# Rezoning Transportation Analysis

Petition Number: 2025-032

Date	Description
04-23-25	First Review (ME)
05-21-25	Second Review (ME)
07-22-25	Third Review (ME)

## CLDSM U-03B1

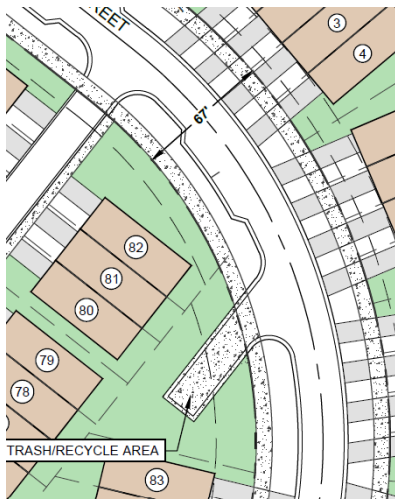
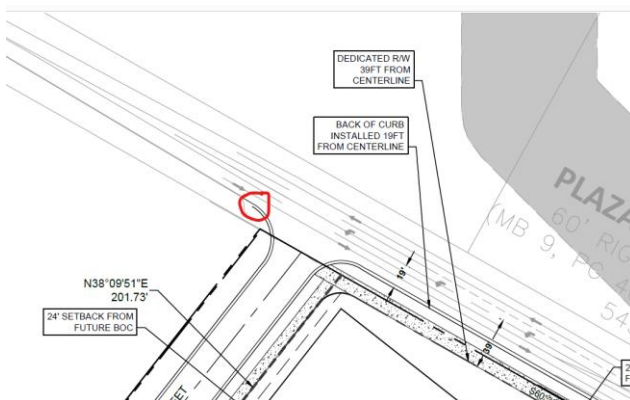
7. Revise site plan and conditional note(s) to commit to both site internal public roads being designed to residential wide streets following CLDSM U-03 with an 8 ft sidewalk. On-street parking should not be located within a roadway curve.

**Outstanding Comment 7/22/25:** Remove on-street parking for the locations pictured below due to both being within curves. All horizontal curves for public roads must be a minimum of 150 feet per the CLDSM section I.B.1. The portion of road leading to the access along Plaza Road will maintain the CLDSM U-03C1 typical section. The other image will maintain the CLDSM U-03B1 typical section.
